**Marion County
Board of County Commissioners**

**PLANNING & ZONING SECTION
STAFF REPORT**

P&ZC Date: 7/29/2024	BCC Date: 8/20/2024
Case Number:	240815ZP	
CDP-AR:	31750	
Type of Case:	Rezoning from Planned Unit Development (PUD) to PUD to modify the unit type of 82 residential units from townhomes to single-family on a previously approved PUD for Whisper Woods.	
Owner	Armstrong Land, LLC	
Applicant	Tillman & Associates Engineering, LLC	
Street Address	No address assigned	
Parcel Number	9007-0000-12	
Property Size	±10.33 acres	
Future Land Use	High Residential (HR)	
Zoning Classification	PUD	
Overlay Zone/Scenic Area	Primary Springs Protection Zone	
Staff Recommendation	APPROVAL WITH CONDITIONS	
P&ZC Recommendation	APPROVAL WITH CONDITIONS	
Project Planner	Eryn Mertens, JD, Planner II	
Developer's Agreement	None	
Related Case(s)	221111ZP, 211006ZP, 051010ZC

Figure 2 Conceptual Plan

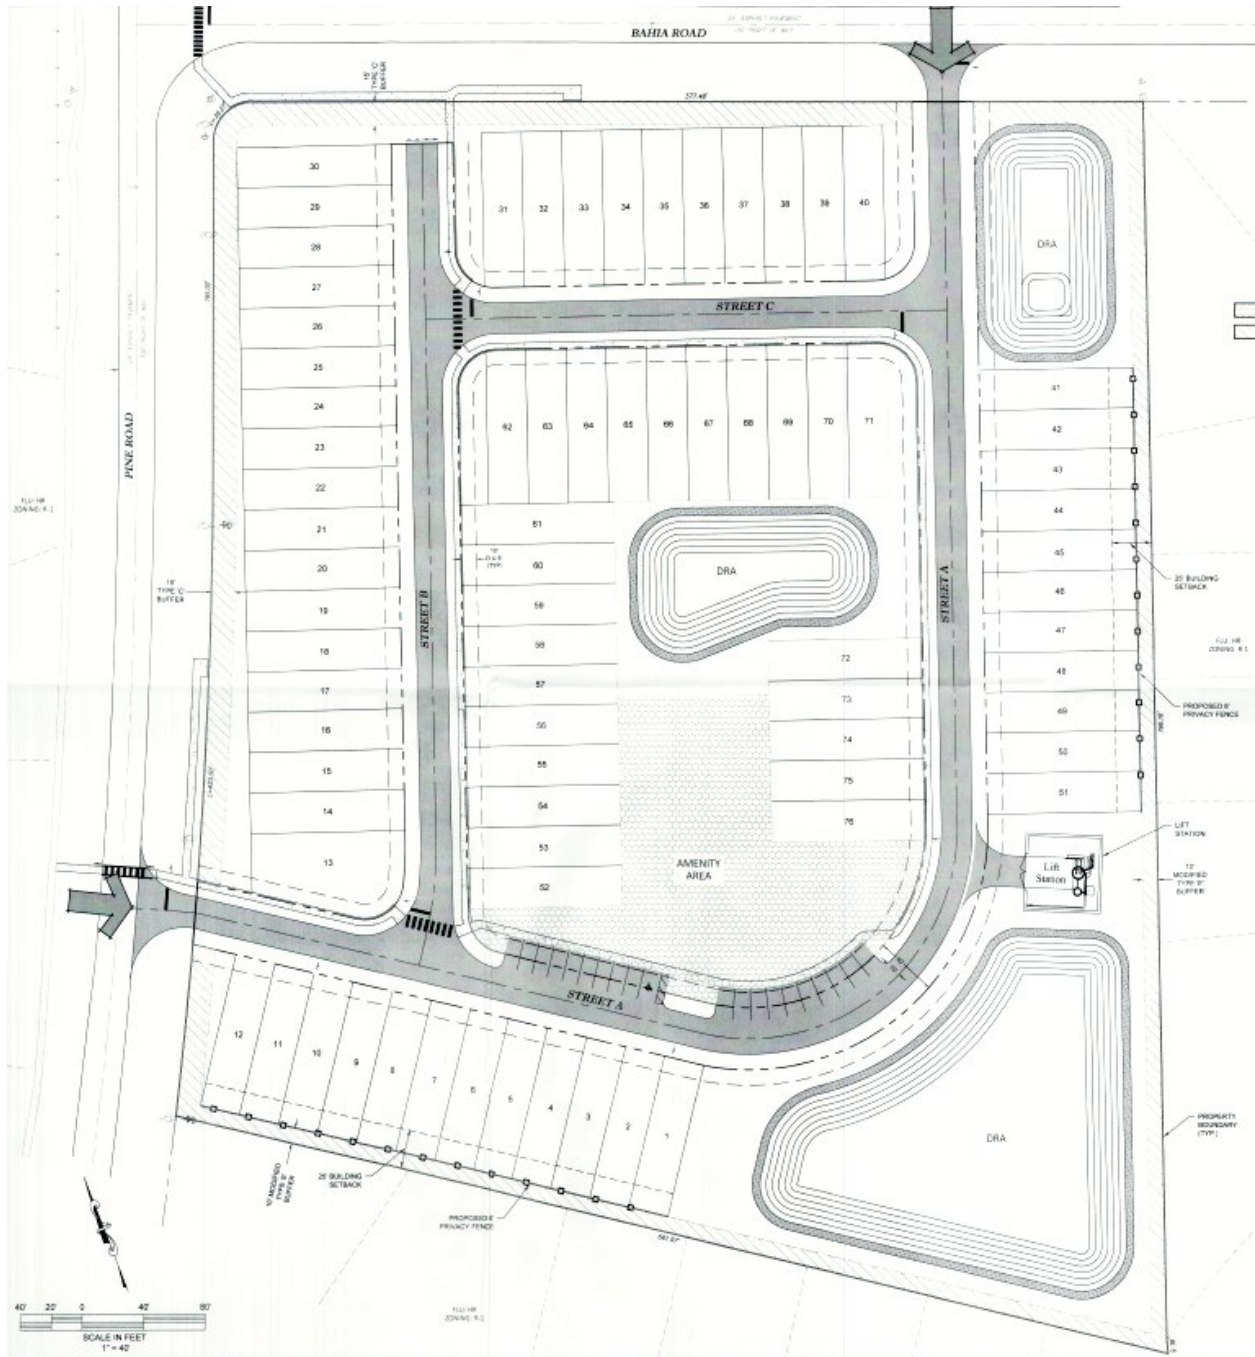
Upon closer inspection of this Concept Plan, along the southeast border of the project, there are 11 proposed lots. The Concept Plan labels the setback from the building to the property line, rather than the lot line of each home, and that total distance is 25'. Inside this 25' is a 10' landscape strip with a 6' fence. This places the PUD home buildings 15' away from the buffer.

The lots proposed inside the PUD are 26' wide lots. Looking at one of the neighboring single-family homes, potentially 4 PUD single-family units would border the rear of an adjacent existing home. See Figure 6 (a snippet of the Concept Plan on the southeast border of the project), and Figure 7, a snippet of the aerial of the same area, here, where the light blue line represents the same border in each figure:

Figure 4
Prior PUD Modification (221111ZP)
Concept Plan as submitted with application

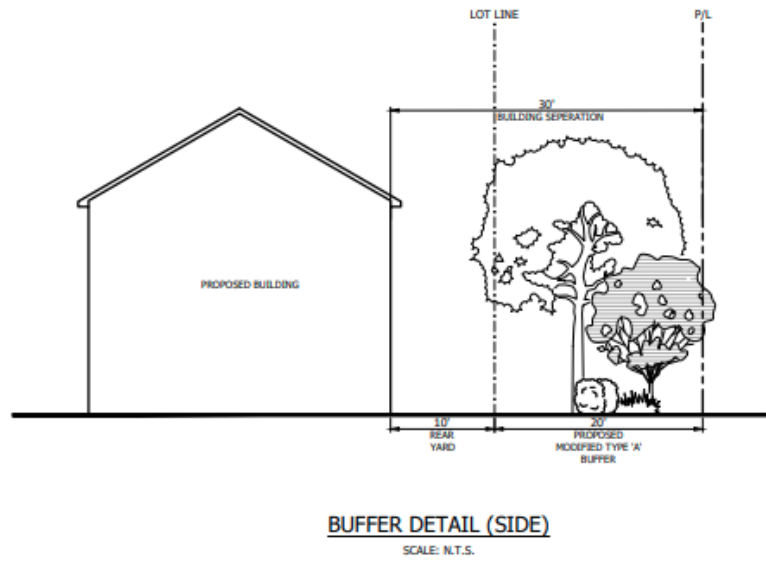
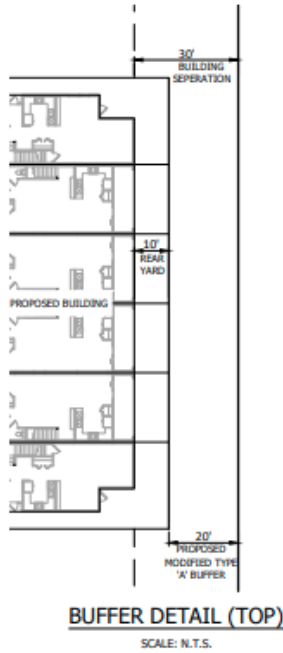
Of note, the last approved PUD required a modified Type-A buffer consisting of 20' with a minimum of 2 shade trees and 5 understory (ornamental) per 100 lineal feet with shrubs and groundcover (which under a PUD may be clustered and not evenly-spaced), and a minimum of a 4-foot high decorative fence barrier along the interior boundary of the Type A Buffer. The resolution specifically mentions the intent of this buffer is to deter access and prevent encroachment into the minimum 20' wide planted buffer. See Figure 4.

Figure 5
Proposed Modified Type E Buffer for eastern and southern boundaries and a 6' opaque fence behind the homes

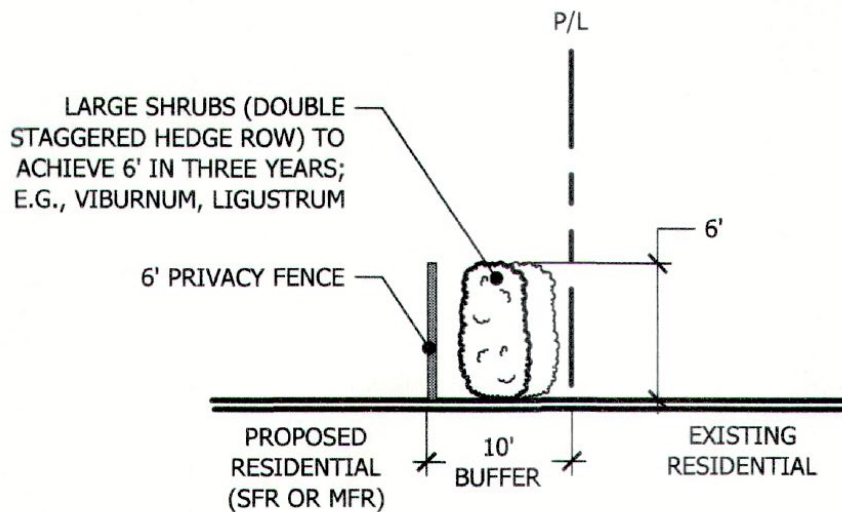
However, along the southeast and southwest boundaries (sharing property lines with the existing surrounding single-family homes), the applicant is **now proposing a Modified Type E buffer (10' wide landscape strip with a 6' privacy fence**; made up of **shrubs** to be planted in a double staggered row and be capable of reaching a **maintained height of 6' within 3 years, no groundcovers used**). From the proposed residential buildings, there is 15' of yard space to the lot line, and then the 10' wide landscape strip is from the lot line to the project boundary/beginning of the neighboring property.

While 6' shrubs, if well maintained, provides a more pleasing aesthetic and effective visual screen from one-story home to one-story home, it does little to visually screen between two-story to one-story homes, even with a 6' privacy fence, especially with the PUD homes being so close to the property boundary (25'). Further, with 26' wide lots, the existing homes along the southeast and southwest boundary of this project could potentially have up to 4 of these two-story PUD homes backing up to their property line.

Staff finds that the application **fails to meet** the requirements within this section, as it fails to comply with the minimum requirements established in the Code, and it also fails to meet the intent of the Code by alternative means. This proposed alternative design, also fails to include, at a minimum, scaled typical vertical and horizontal cross-sections of the buffer, including depictions of all proposed alternative buffer improvements and scaled representations of the existing principal structures and improvements that are located on the adjoining properties being buffered from the PUD. Finally, the new proposed buffers also fail to meet the intent of the existing requirements as stated in the Resolution (i.e., it is silent as to the measures taken to prevent encroachment into the buffer by the PUD property owners, which was specifically called out in the existing requirements).

Staff does not support the requested buffer design change, thereby recommending to leave the existing Modified Type A Buffer requirements in place along the southeast and southwest boundaries.

- Buffers shall remain unchanged from the existing buffer requirements for this PUD. See Resolution 22-R-577.

Figure 6
Project Snippet

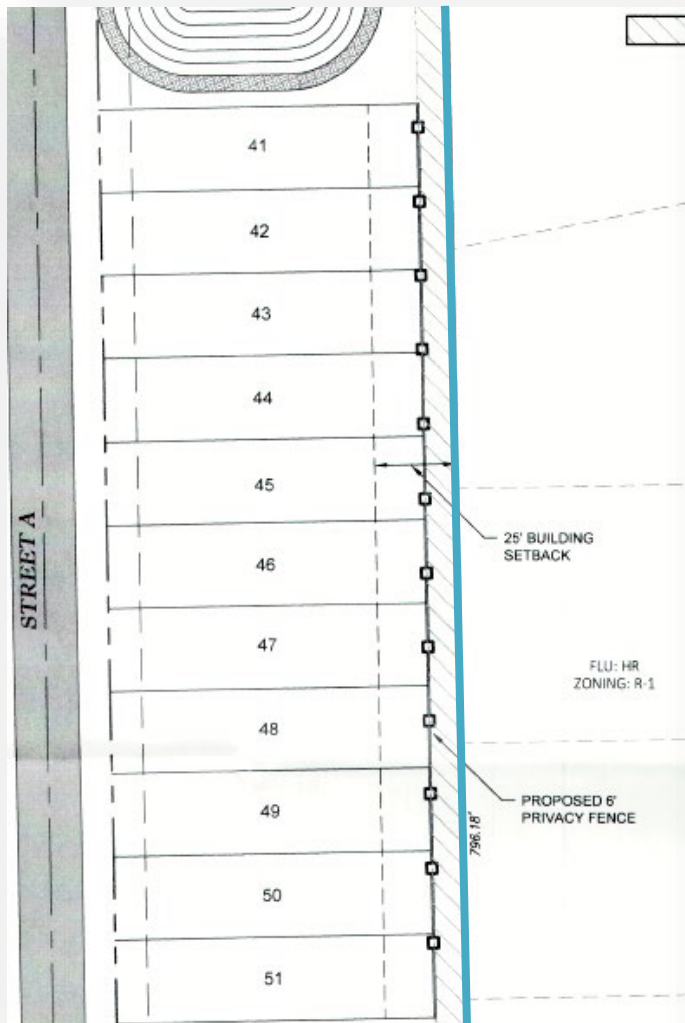
While this request is seeking to increase the height of the currently-required decorative fence, 2 additional feet on the height of the fence does not fully address the inconsistency in types of residences between the established homes bordering this PUD and the proposed project, especially with the lesser intense buffer proposed in this modification application.
